# Differential Return Loss for Annex 120d

*Addressing to Comments i-34, i-74, i-75*

Richard Mellitz, Samtec  
Adee Ran, Intel

March 2017 IEEE802.3 Plenary, Vancouver, BC, Canada

# Option A: Go Back to Clause 93 and Annex 83d

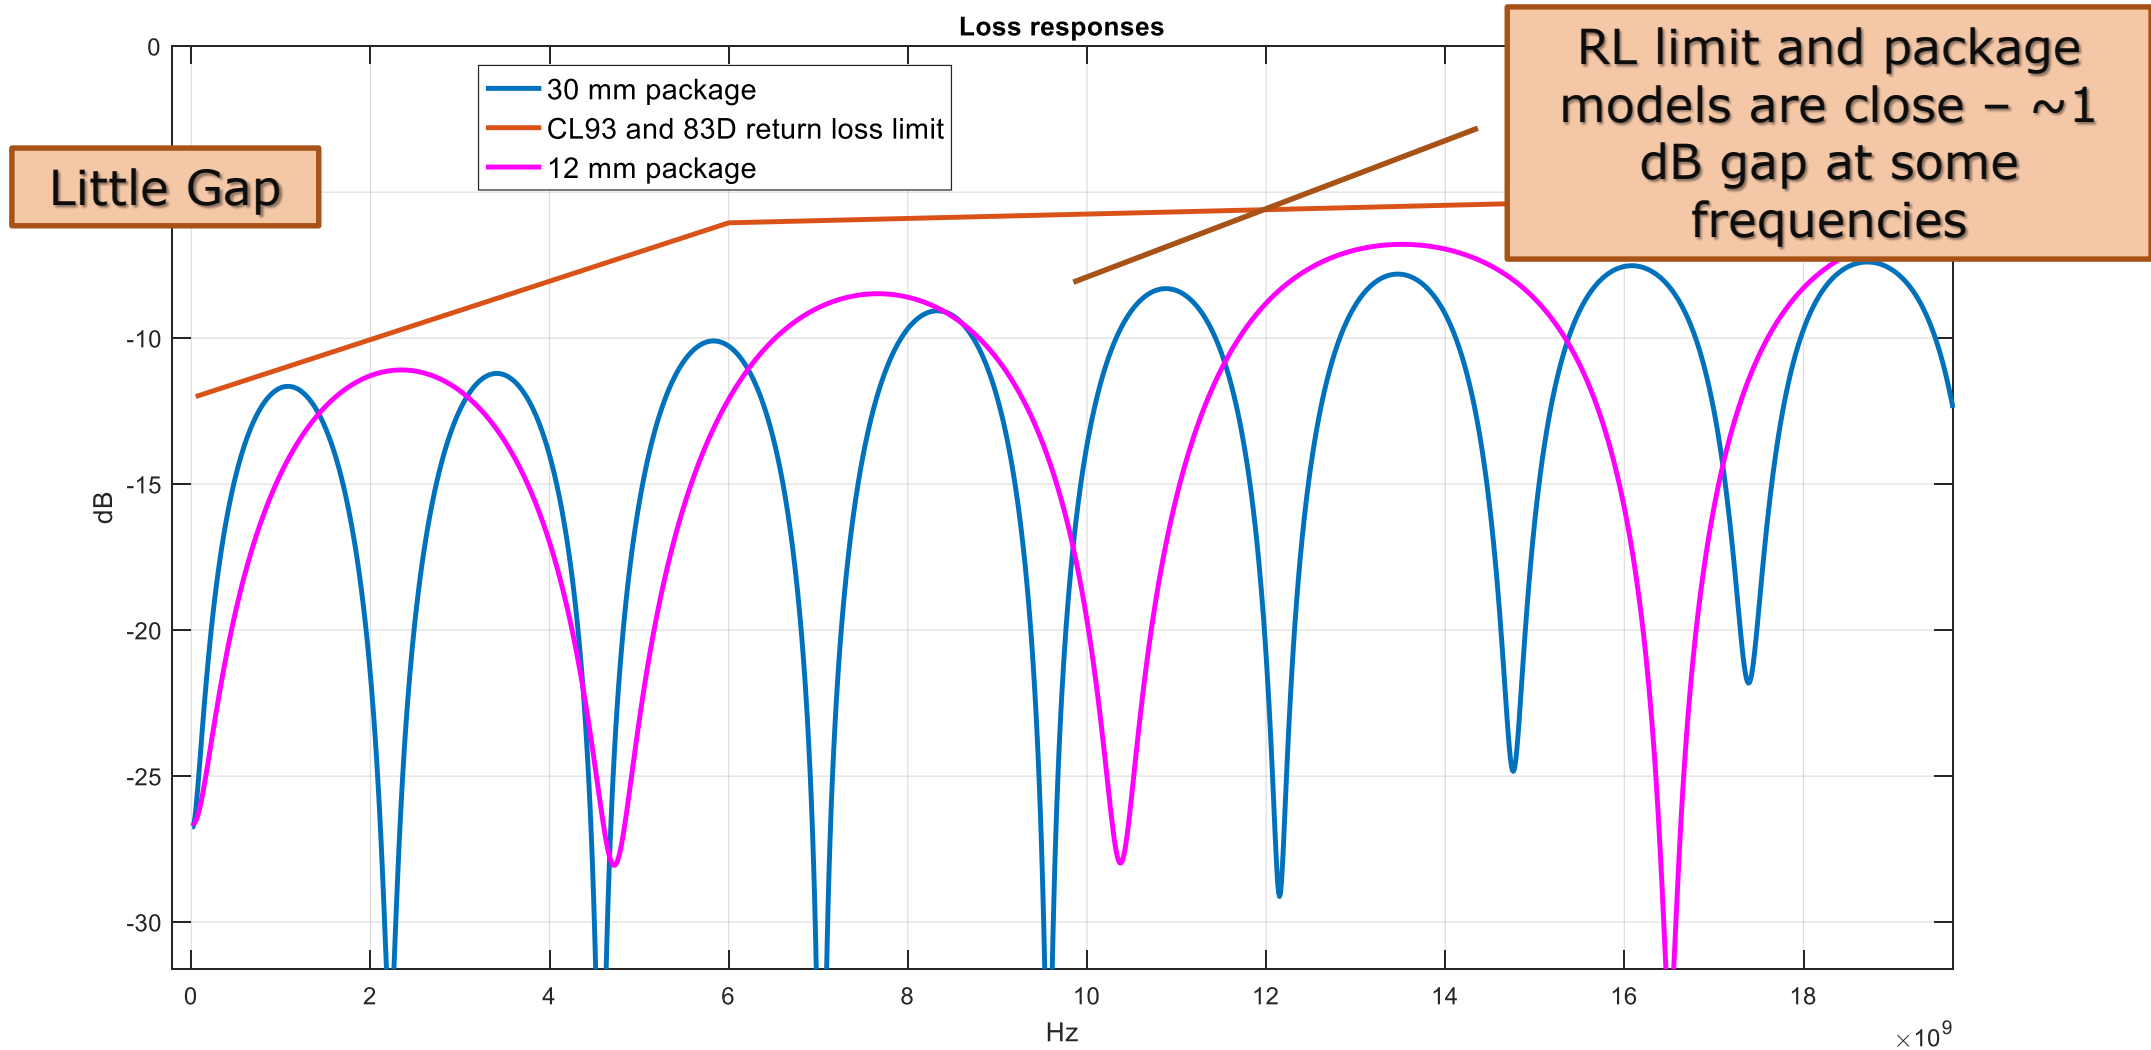
Device package model uses characteristic impedance  $Z_c$  of 78.2 Ohms (does not appear in the table)

## COM package return loss compared to RL limit

# OPTION B: do nothing and keep what is in D3.0

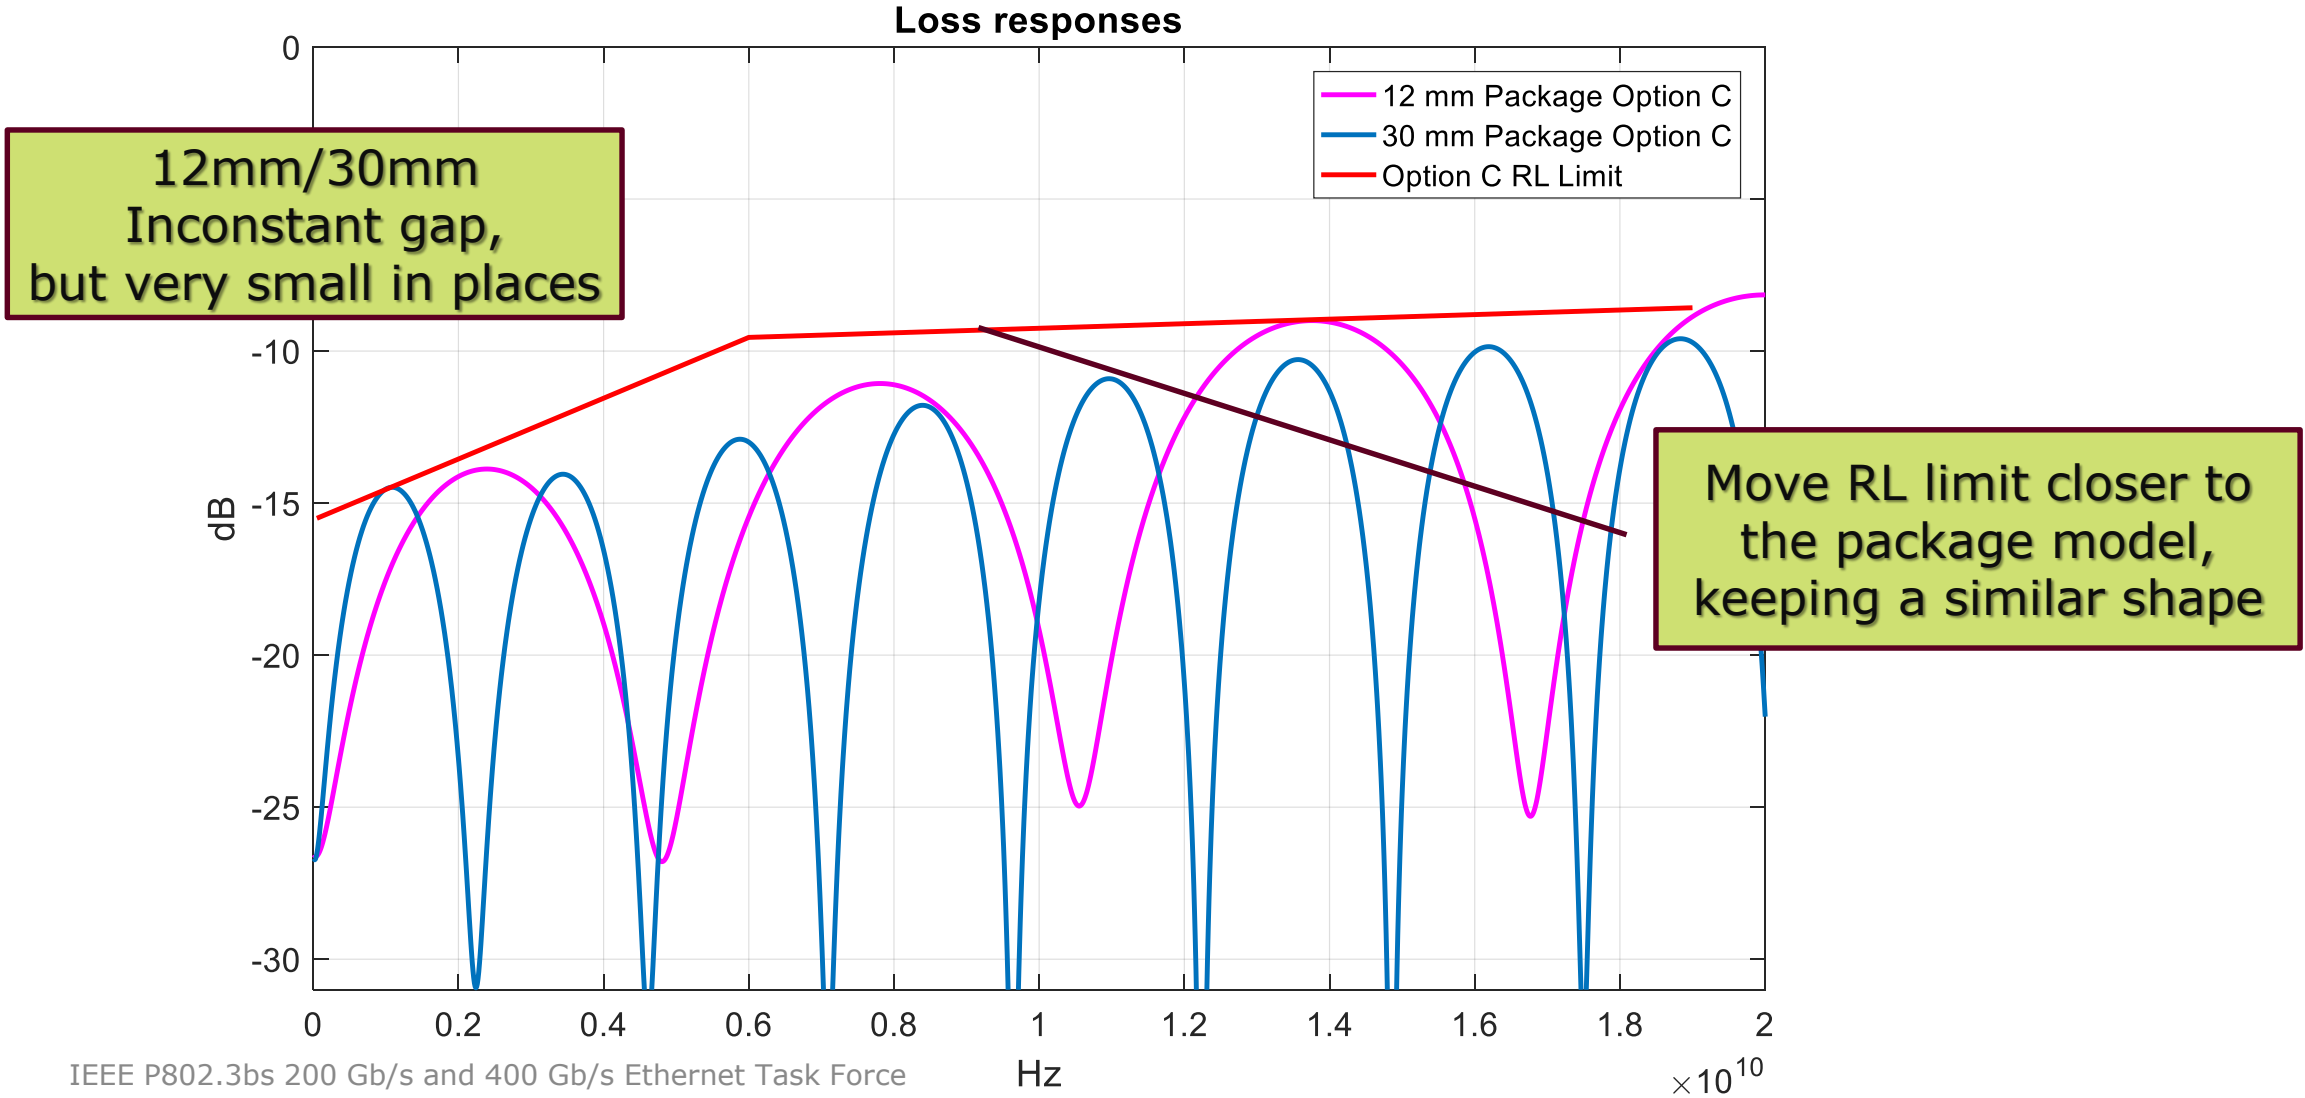
## *COM package return loss compared to RL limit*

(not aligned with Clause 137 P802.3cd Draft 1.2)

# Option D: Pedantic COM package parameters for Option C Return Loss

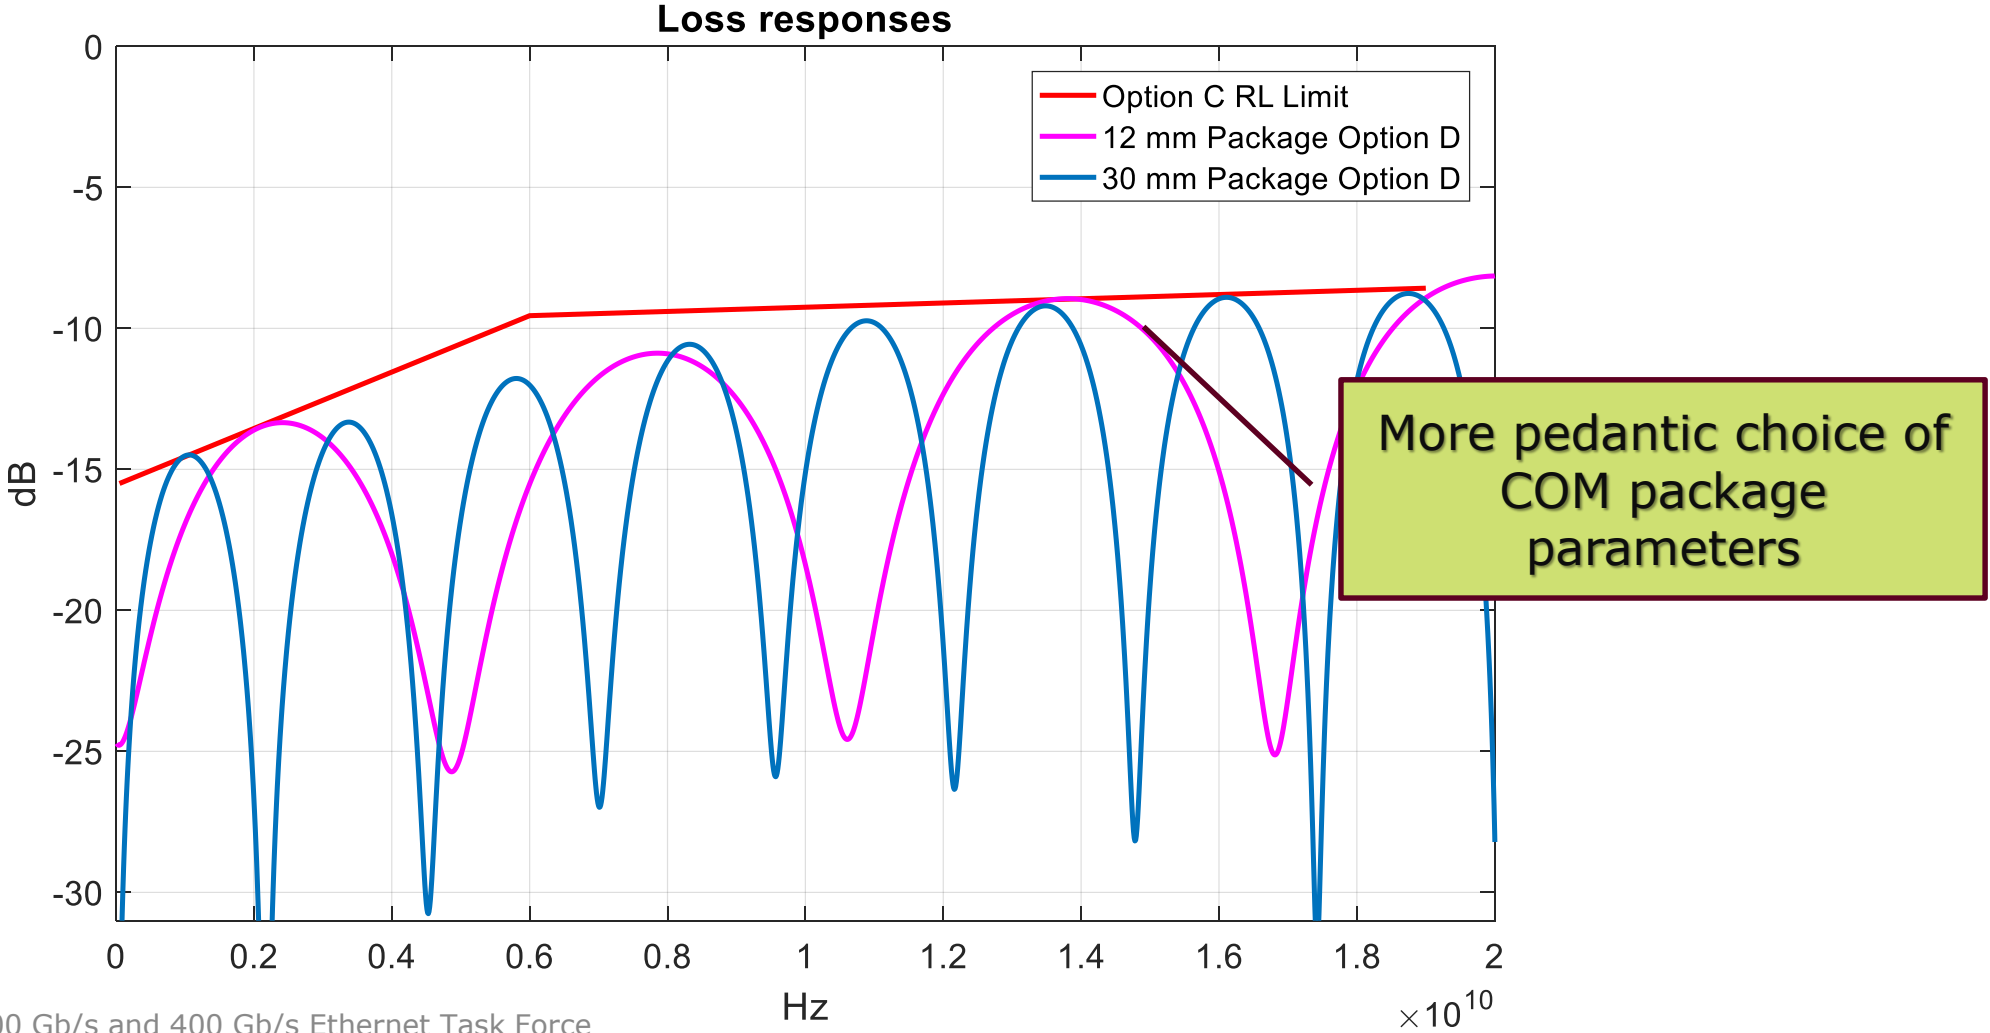
Device package model			
Single-ended device capacitance Test 1	$C_d$	$1.78 \times 10^{-4}$	nF
Single-ended device capacitance Test 2	$C_d$	$2.7 \times 10^{-4}$	nF
Transmission line length, Test 1	$Z_p$	12	mm
Transmission line length, Test 2	$Z_p$	30	mm
Single-ended package capacitance at package-to-board interface	$C_p$	$1.1 \times 10^{-4}$	nF
Package transmission line characteristic impedance Test 1	$Z_c$	84.5	$\Omega$
Package transmission line characteristic impedance Test 2	$Z_c$	82	$\Omega$
Single-ended termination resistance Test 1	$R_d$	45	$\Omega$
Single-ended termination resistance Test 2	$R_d$	50.5	$\Omega$
